IN THE DRAWINGS

The Examiner stated that the sheets of drawings filed on April 8, 2002 have been received but not approved because Applicants have not submitted a proposed drawing correction in the form of a pen-and-ink sketch showing the changes in red.

FIG. 2B

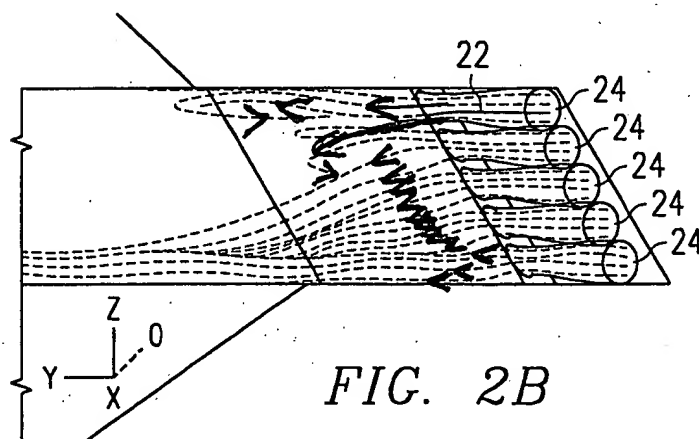
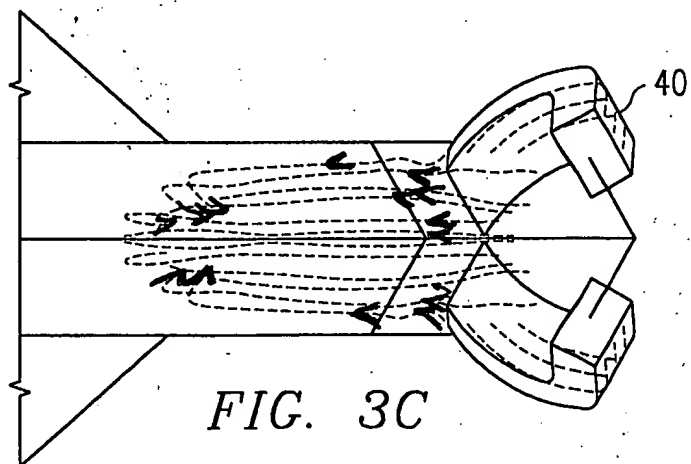
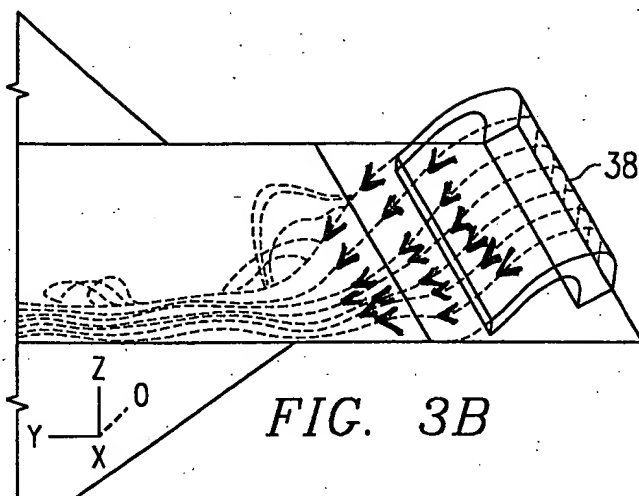
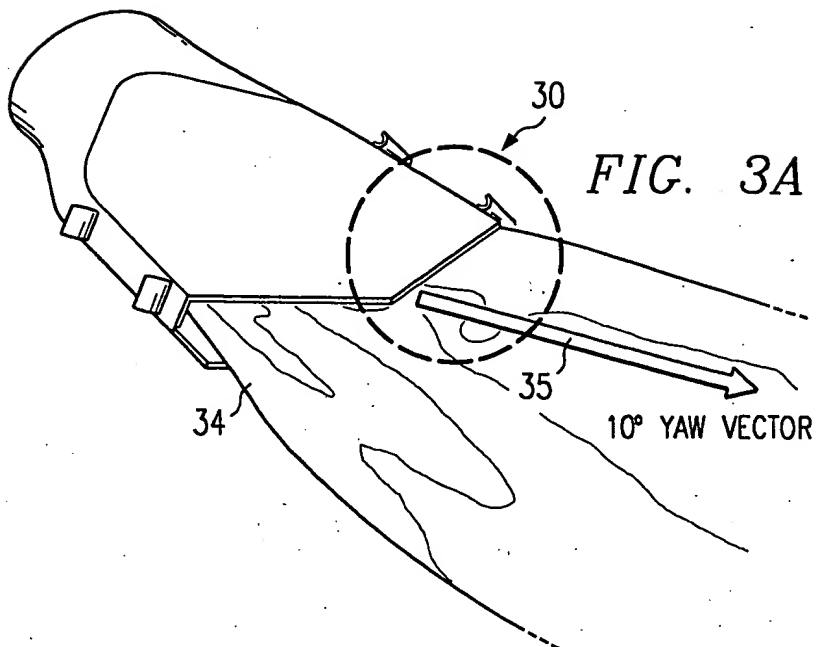
Applicants respectfully submit that flow arrows for the injected fluid have been added to Figures 2B, 3B, 3C, 3D, and 3E. Applicants respectfully submit that the pitch vector has been modified in Figure 5B to more clearly show that this vector has a vertical component directing the vector into the page.
